Application No. 10/713,437

## AMENDMENTS TO THE DRAWINGS

#### REMARKS

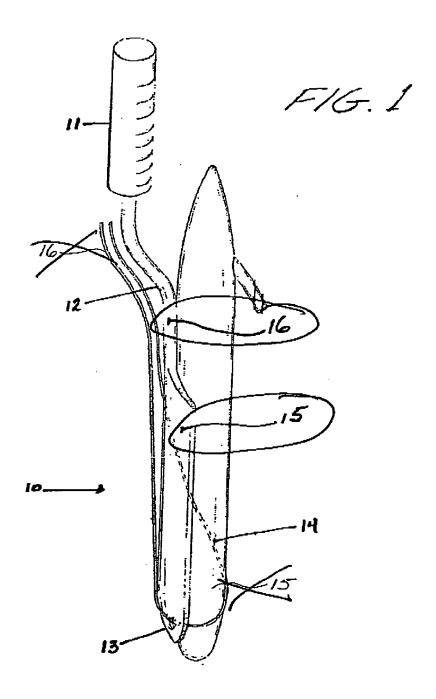
Fig. 1 has been amended to include additional item numbers that correspond with the description amended in the specification. Specifically, item numbers 15 and 16 have been added to Fig. 1, wherein item number 15 is the outwardly angled shaft section and item number 16 is the linear handle section.

Applicant has amended Fig. 1 to include additional item numbers that correspond with the description amended in the specification. Specifically, item numbers 15 and 16 have been added, wherein item number 15 is the outwardly angled shaft section and item number 16 is the linear handle section. The location of item numbers 15 and 16 have changed from the last amendment. The outwardly angled shaft section 15 is outwardly angled from the center line of the linear handle section. The portion of the outwardly angled shaft section 15 that is visible on Fig. 1 is replicated on the other side of the tool, and together, the outwardly angled shaft section and its replicate form a convexity, or a roundness in the tool so that it may fit over the rounded prosthesis. Applicant submits that the drawings should now be clear and requests that the objection to the drawings be withdrawn.

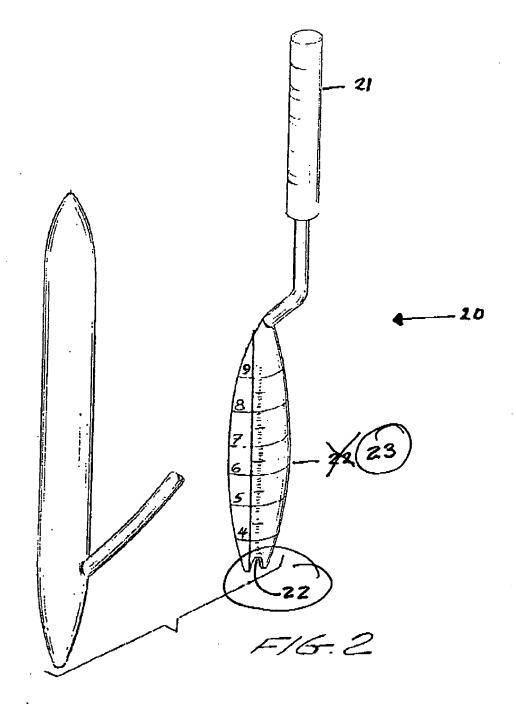
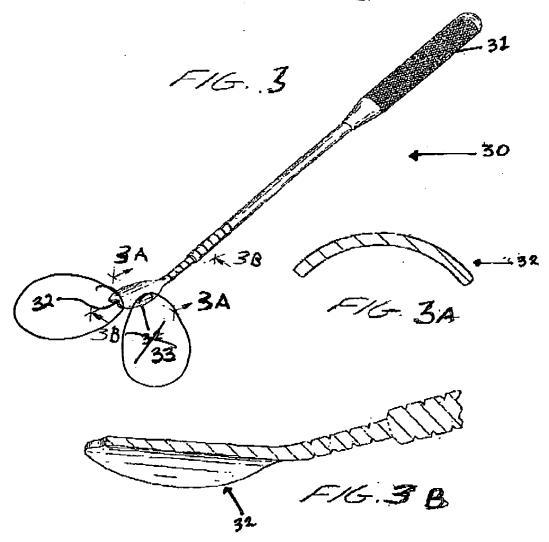
Figs. 2 and 3 have been amended to include additional item numbers that correspond with the description amended in the specification. Specifically, item numbers 23 and 33 have been added to identify the shaft. Item numbers 22 and 32 have been moved to point more particularly to the receptacle (notch) of the tool.

Applicant has amended Figs. 2 and 3 to add item numbers 23 and 33 which identify the shaft, in cooperation with the amendment to the specification presented above. Item numbers 22 and 32 have been moved on the drawing to show that they refer to the notch, or receptacle, at the end of the shaft of the tool.
